FEDERAL ENERGY  
REGULATORY COMMISSION

FERC Project Nos. 2525,  
2595, 2522, 2546, 2560, and  
2581

The order modifying and approving the water quality monitoring plans for the Caldron Falls Hydroelectric Project (FERC Project No. 2525), the High Falls Hydroelectric Project (FERC Project No. 2595), the Johnson Falls Hydroelectric Project (FERC Project No. 2522), and the Sandstone Hydroelectric Project (FERC Project No. 2546), the Potato Rapids Hydroelectric Project (FERC Project No. 2560), and the Peshtigo Hydroelectric Project (FERC Project No. 2581) dated either September 14, 1998 or September 15, 1998 states that the licensee (Wisconsin Public Service Corporation, WPSC) shall determine the location of the monitoring equipment in consultation with the Wisconsin Department of Natural Resources (WDNR). If the licensee and the WDNR cannot agree on a location for the monitoring, the licensee shall file its recommendations, along with the WDNR comments, for Commission approval.

SUBJECT: Proposed Water Quality Monitoring Device Locations, FERC Project  
Nos. 2560, 2525, 2522, 2546, 2595, and 2581

**JOHNSON FALLS HYDRO PLANT  
PLANT SITE LAYOUT**

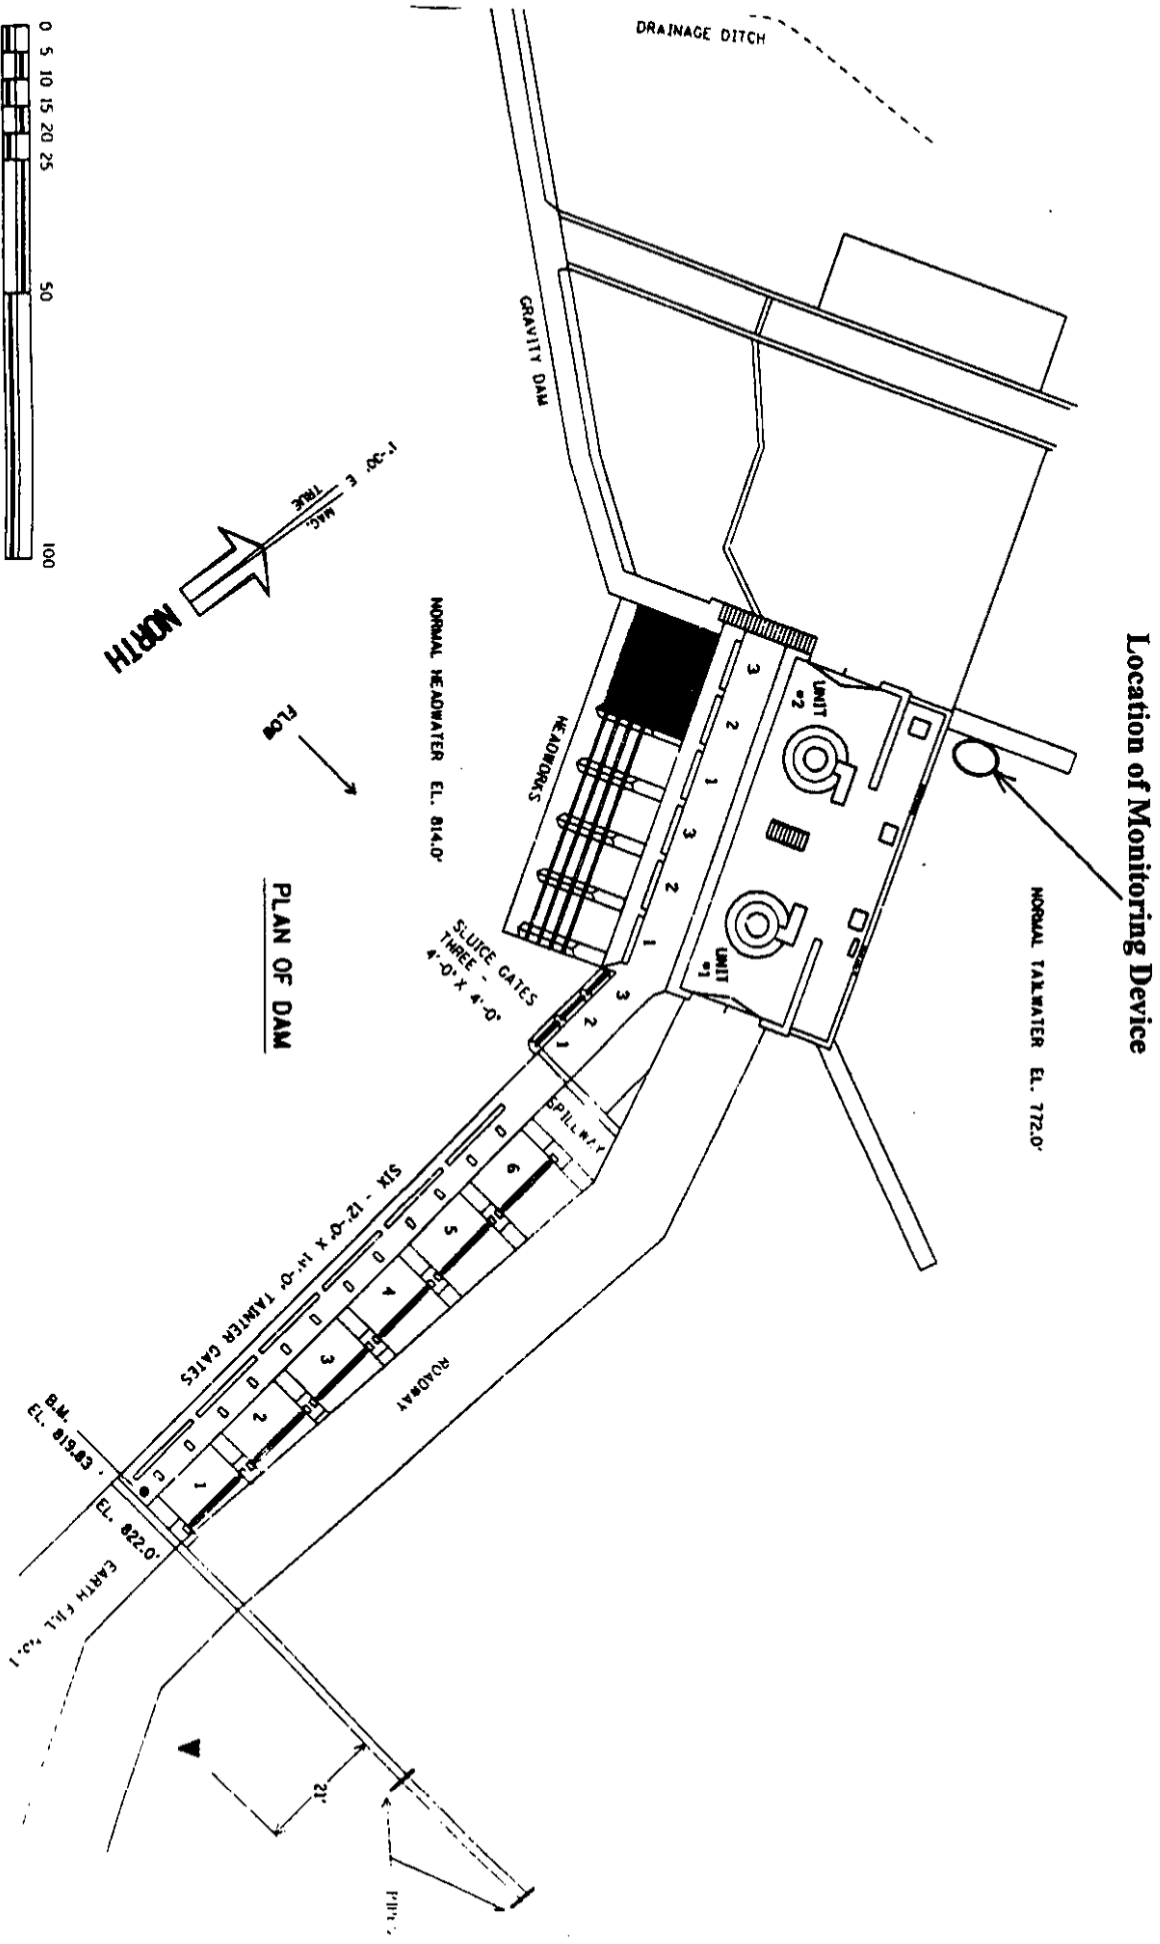
We would suggest that the exact location for the placement of the water quality monitoring device be selected with the agency personnel during a site visit. The location proposed may be acceptable, however we would prefer to check this out during a site visit.

The proposed location of the downstream monitoring device will remain the same as the location utilized for the relicensing water quality monitoring. The structure for retaining

the water quality monitoring device remains in place and requires no modification for the proposed location. The proposed location is in the tailwater outfall and is attached to the powerhouse structure itself. WPSC does not believe it is necessary to determine the exact location of the monitoring device through a site visit with the WDNR because the past consultation record has proven an agreement on the locations is unlikely. The exact placement of the monitoring device is influenced by safety, ease of access, and protection from vandalism and theft. These factors are apparently not considered by the WDNR. Therefore, WPSC is providing an approximate location in the recommendations that will provide a format (location within the stream, proximity to the dam, etc.) which allows the agency concerns about the quality of data to be addressed.

**PLAN OF DAM**

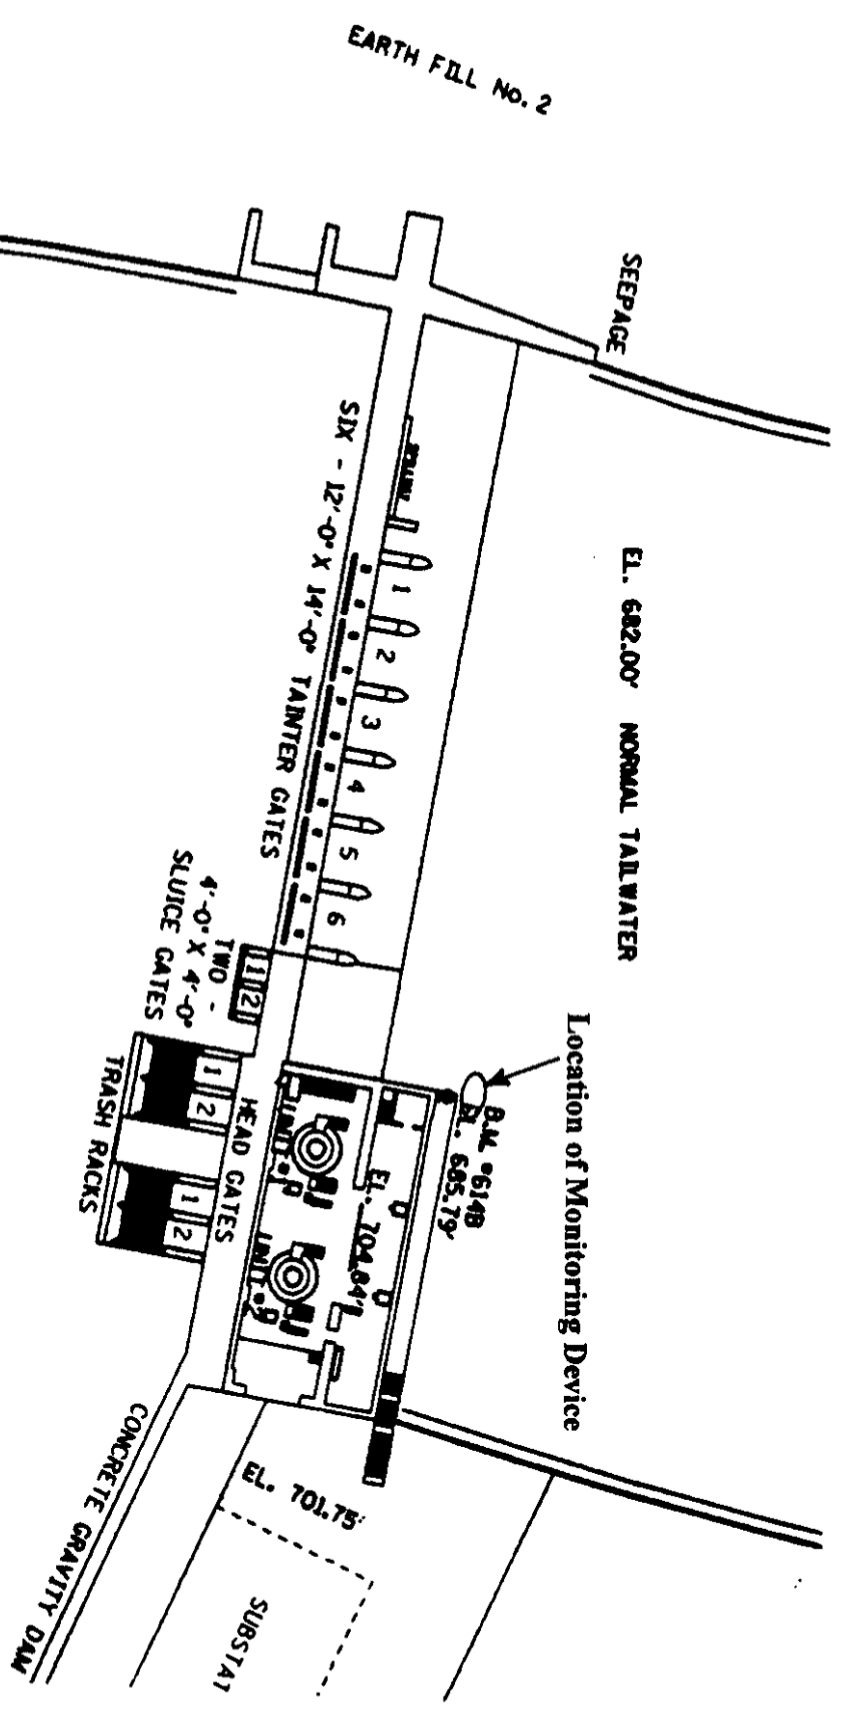
We would suggest that the exact location for the placement of the water quality monitoring device be selected with the agency personnel during a site visit. The location proposed may be acceptable, however we would prefer to check this out during a site visit.

The proposed location of the downstream monitoring device will remain the same as the location utilized for the relicensing water quality monitoring. The structure for retaining the water quality monitoring device remains in place and requires no modification for the proposed location. The proposed location is in the tailwater outfall and is attached to the powerhouse structure itself. WPSC does not believe it is necessary to determine the exact location of the monitoring device through a site visit with the WDNR because the past consultation record has proven an agreement on the locations is unlikely. The exact placement of the monitoring device is influenced by safety, ease of access, and protection from vandalism and theft. These factors are apparently not considered by the WDNR. Therefore, WPSC is providing an approximate location in the recommendations that will provide a format (location within the stream, proximity to the dam, etc.) which allows the agency concerns about the quality of data to be addressed.

POTATO RAPIDS HYDRO PLANT  
 PLANT SITE LAYOUT

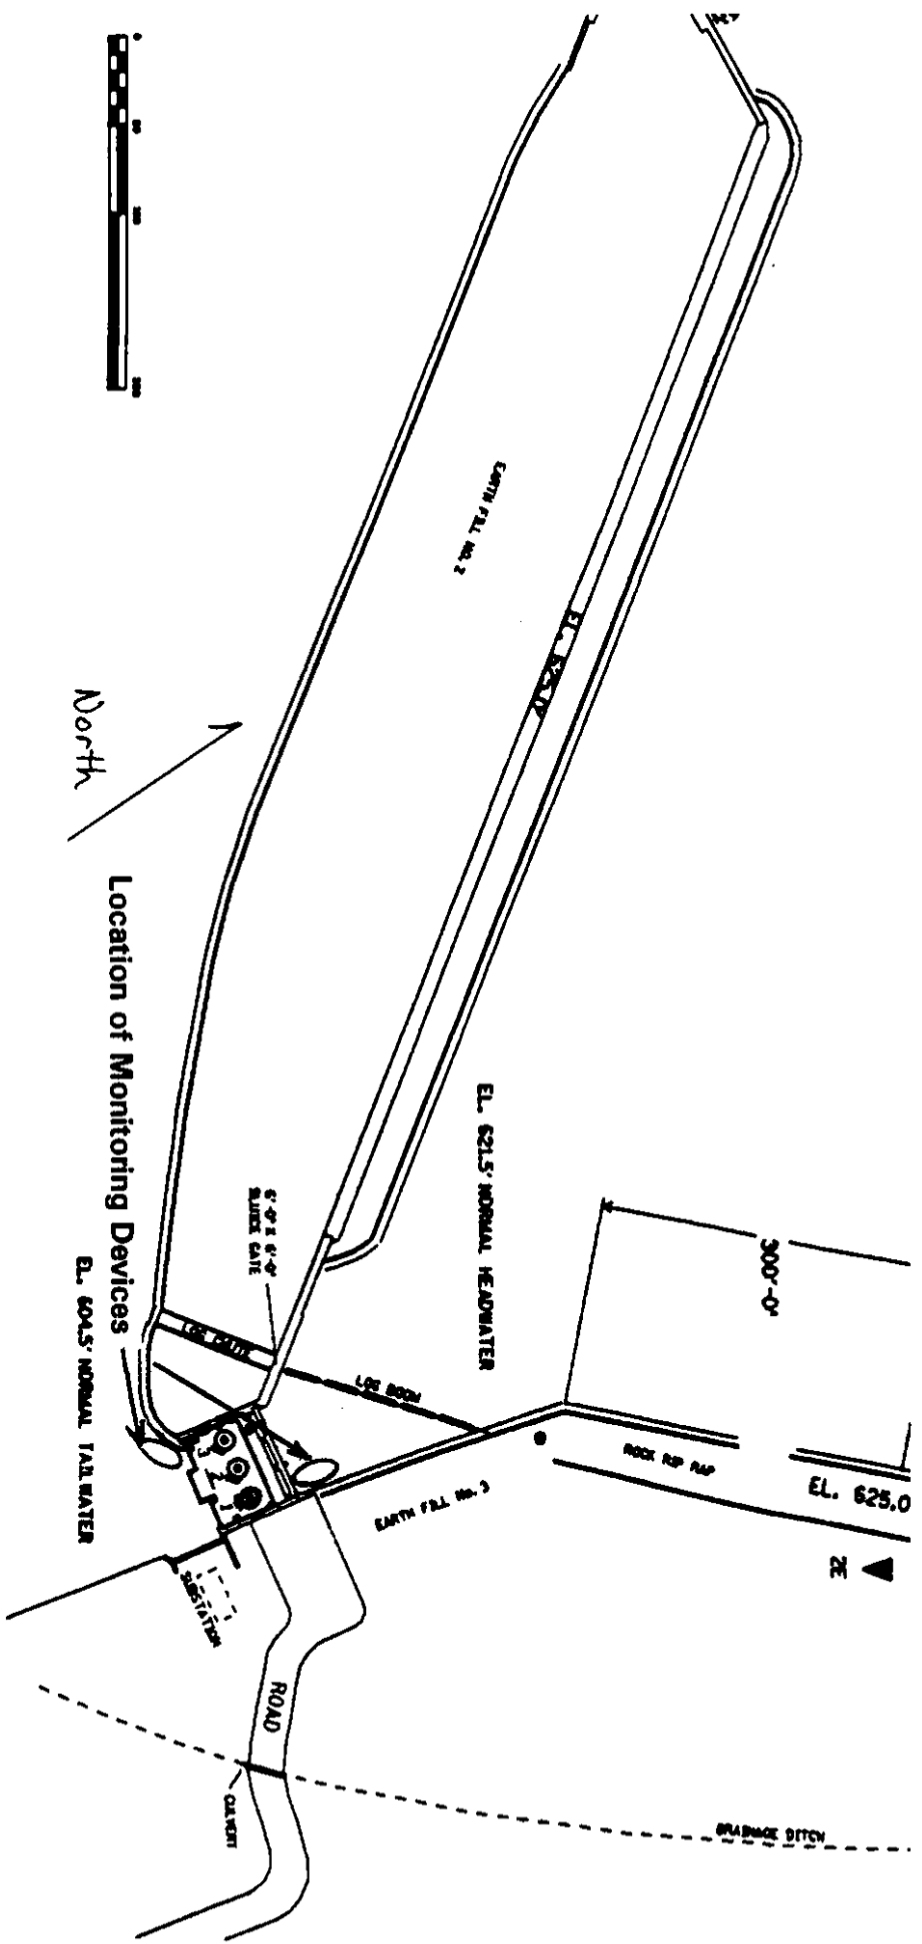
The location that you are proposing for the upstream monitoring device is unacceptable to the Wisconsin Department of Natural Resources (WDNR). By placing the device at the northeast corner of the powerhouse you will not get a representative sample of the water quality above the project. With the operation of different turbine units at different times of the year there will be varying flow patterns coming into the powerhouse. This will impact water quality. We would suggest that you look for a location in the vicinity of the County Highway E bridge located above the impoundment. The exact locations of both the upstream and downstream water quality monitoring devices should be determined at an onsite meeting with representatives of the agencies.

The proposed location of the upstream monitoring device has been modified by moving the location approximately 100 feet to the north along the wingwall away from the powerhouse to address the concerns associated with the operation of different turbine

units provided in the WDNR comments. The location of the downstream monitoring device will remain the same as the location utilized for the relicensing water quality monitoring. The structure for retaining the water quality monitoring device remains in place and requires no modification for the proposed location. The proposed location is in the tailwater outfall and is attached to the dam structure itself. WPSC does not believe it is necessary to determine the exact location of the monitoring device through a site visit with the WDNR because the past consultation record has proven an agreement on the locations is unlikely. The exact placement of the monitoring device is influenced by safety, ease of access, and protection from vandalism and theft. These factors are apparently not considered by the WDNR. Therefore, WPSC is providing an approximate location in the recommendations that will provide a format (location within the stream, proximity to the dam, etc.) which allows the agency concerns about the quality of data to be addressed.
